# CHABOT- LAS POSITAS COMMUNITY COLLEGE DISTRICT

## **Addendum No. 1** **INVITATION FOR BID NO.: 09-04** **HazMat Remediation for Building 500 – Chabot College**

Attachment No. 1  
Lay Down Storage Area Diagram

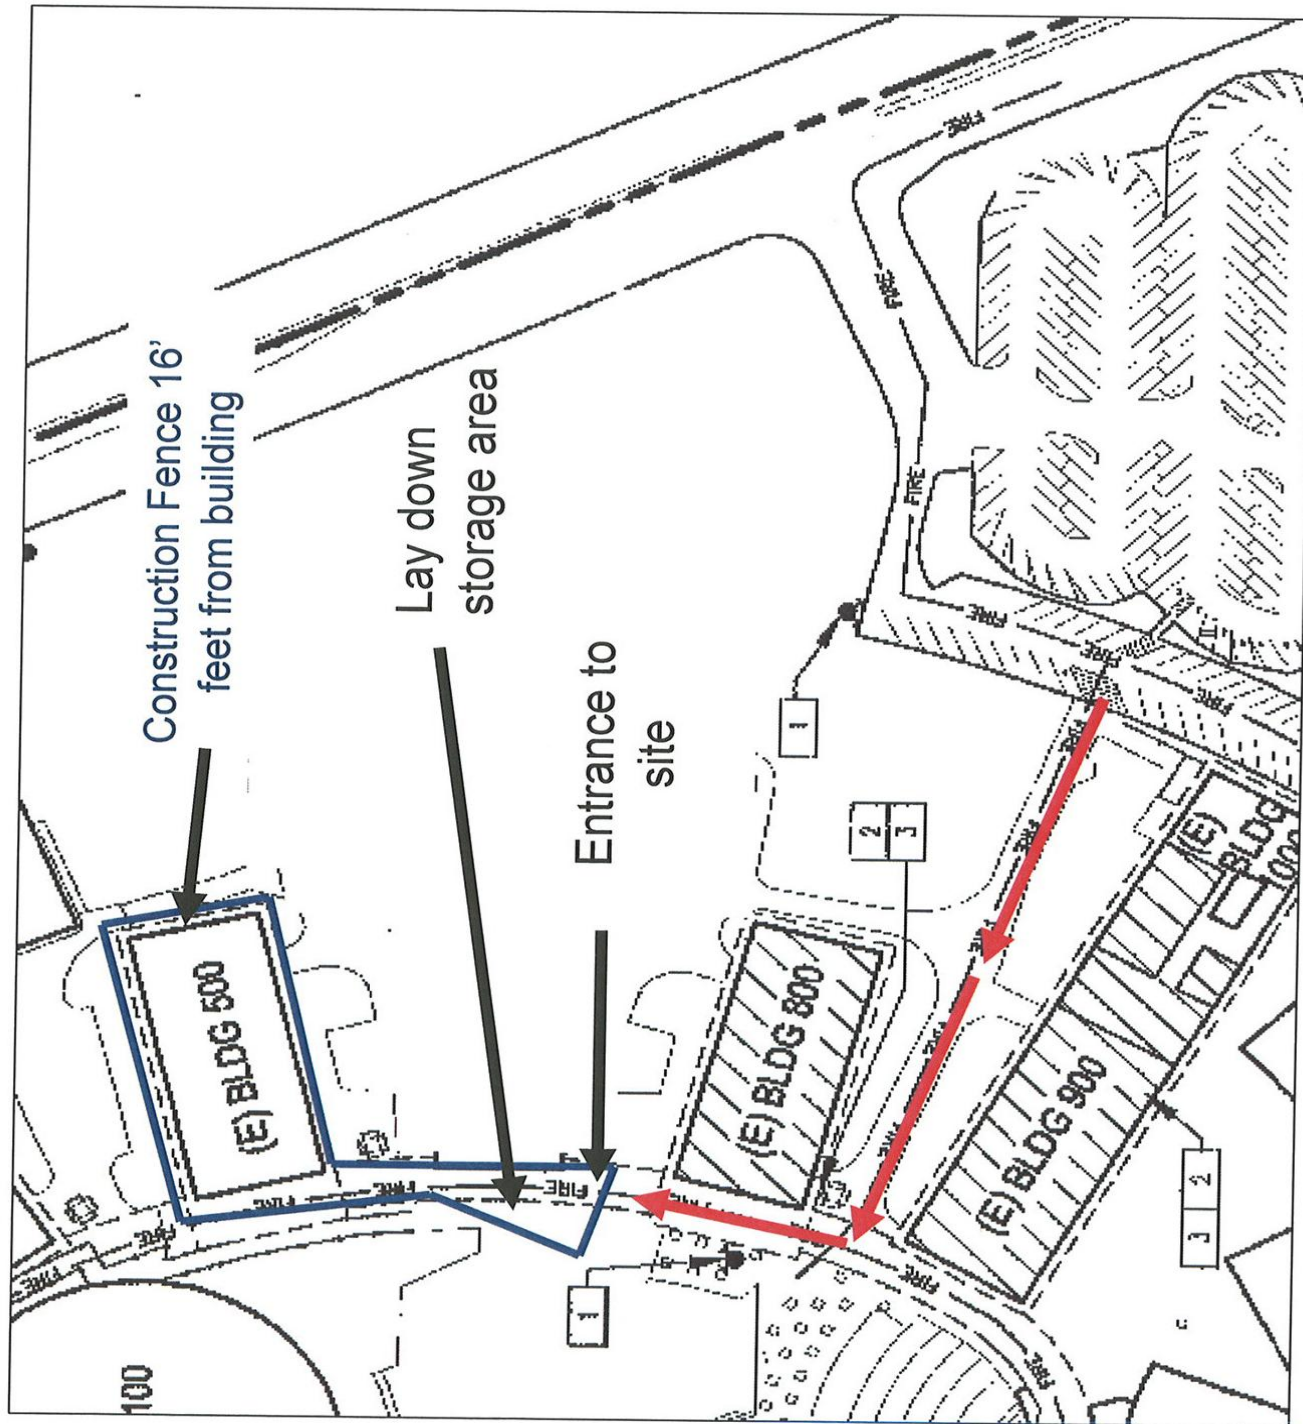
2. Any references to Building 300 are to be disregarded. The scope of work for Building 300 is not part of this project.
3. Attachment No. 1, entitled "Lay Down Storage Area" diagram indicates the entrance to the site route which should be used by the abatement contractor. The required construction fencing shall be installed and maintained by the abatement contractor and the lay down storage area will be available to the contractor for the placement of dumpsters and other items. Delivery and removal of the dumpsters will be allowed only until 7:30 AM each day without exceptions.
